**Commonwealth Edison**

September 18, 1981

Subject: Byron Station Units 1 and 2  
Braidwood Station Units 1 and 2  
Responses to FSAR Questions  
NRC Docket Nos. 50-454, 50-455,  
50-456 and 50-457

ATTACHMENT A

Byron/Braidwood  
FSAR  
Figure 3.8-53  
Auxiliary Building  
SECTION

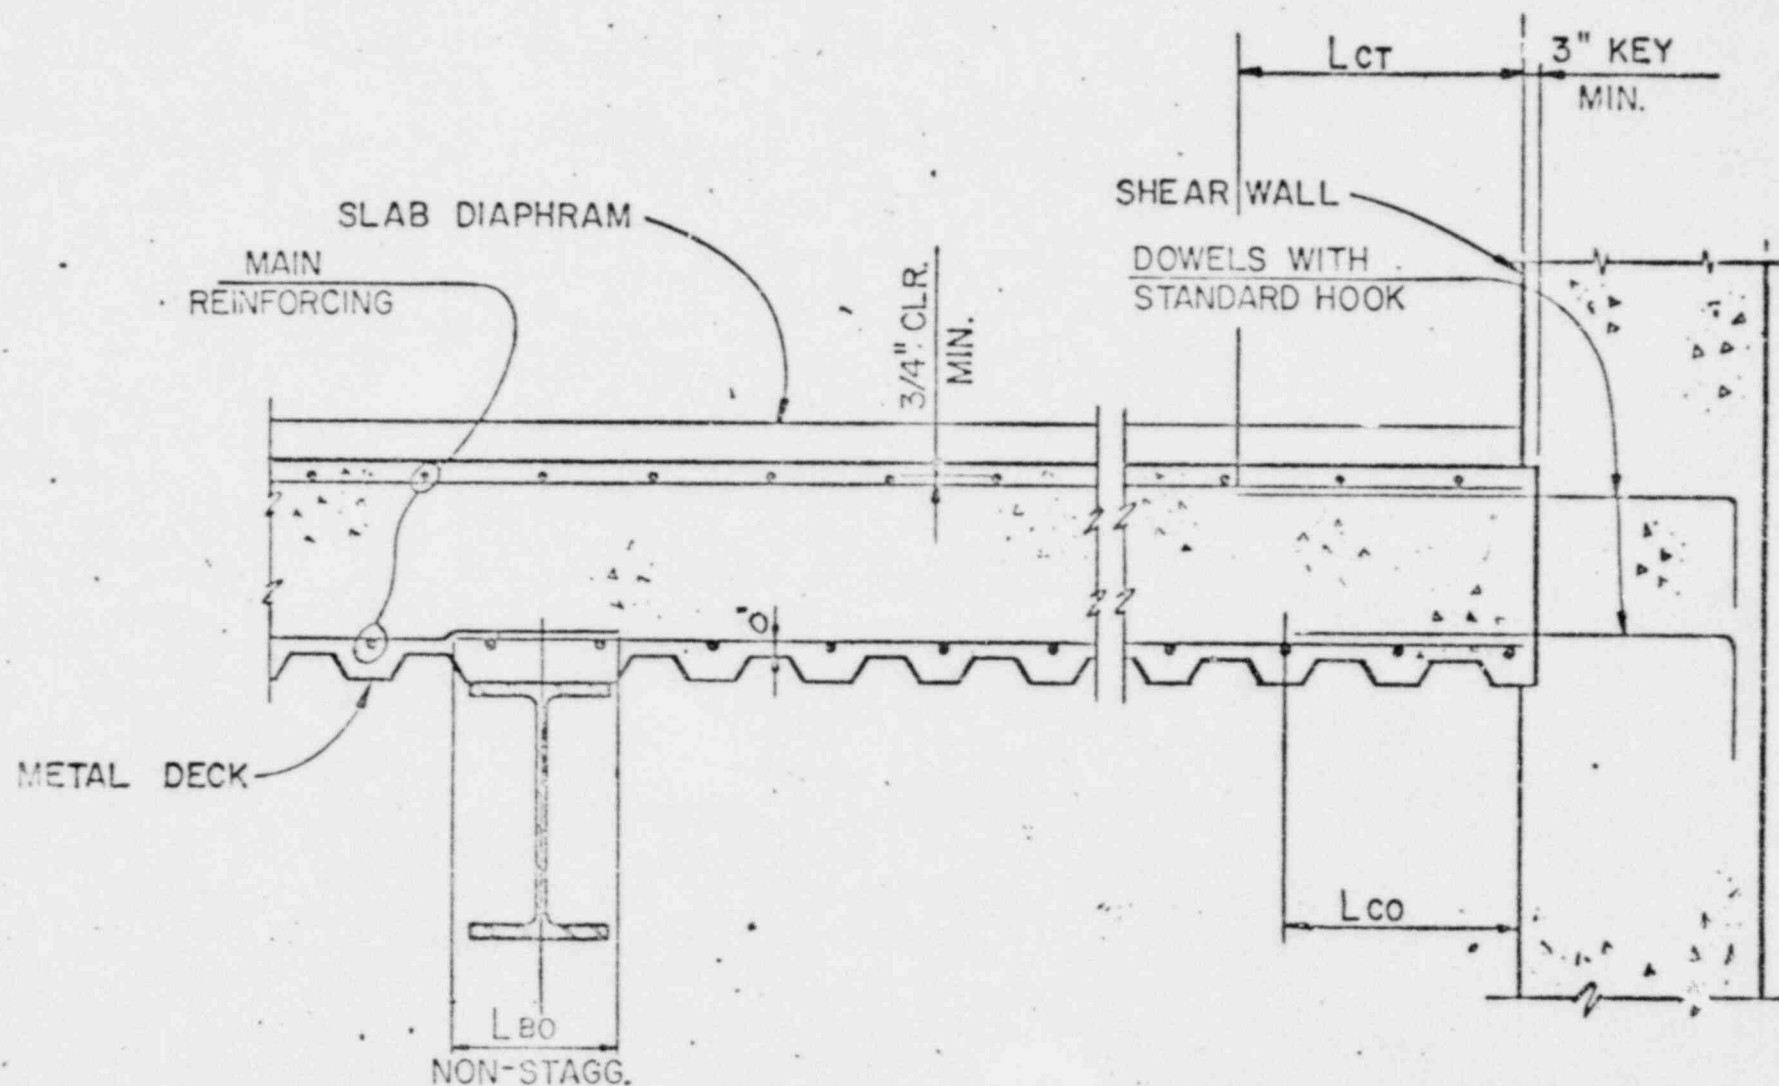
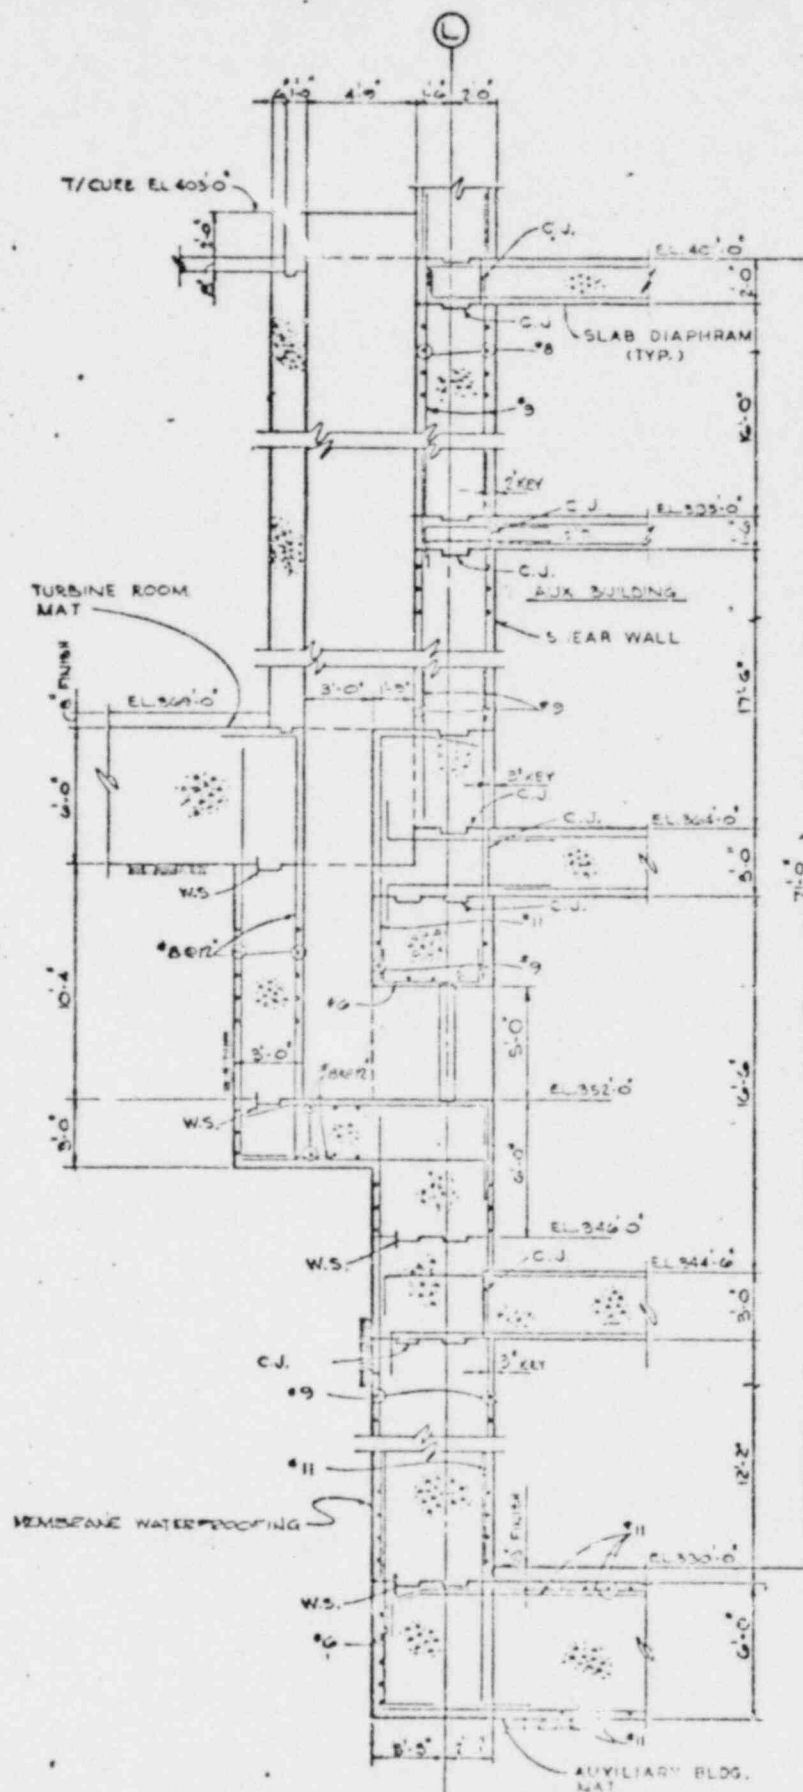
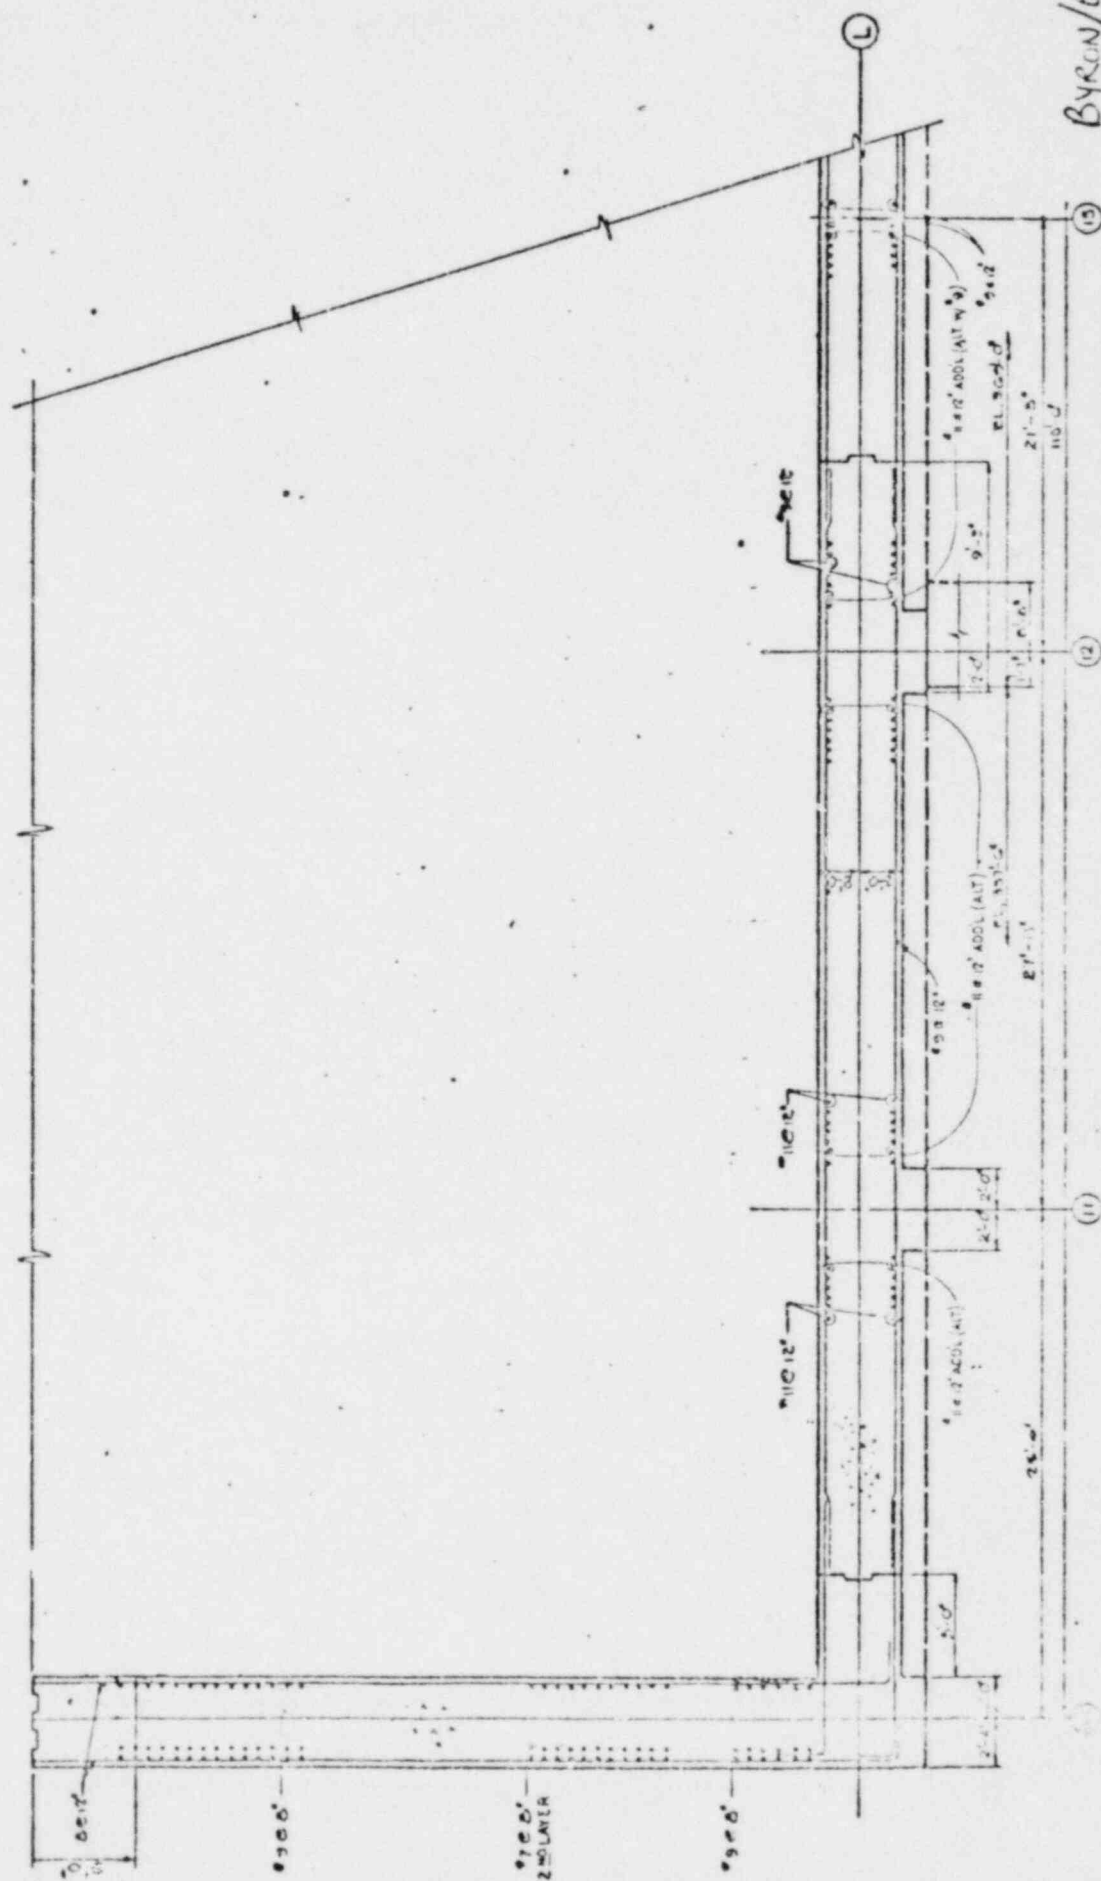
A plan view of auxiliary-fuel handling building shear walls, elevation view, shear wall-slab diaphragm connection (above grade and below grade), and a typical wall corner are shown in new Figures 3.8-52 through 3.8-56. These figures, along with the information in Subsection 3.8.4.4, provide sufficient detail for a structural review.
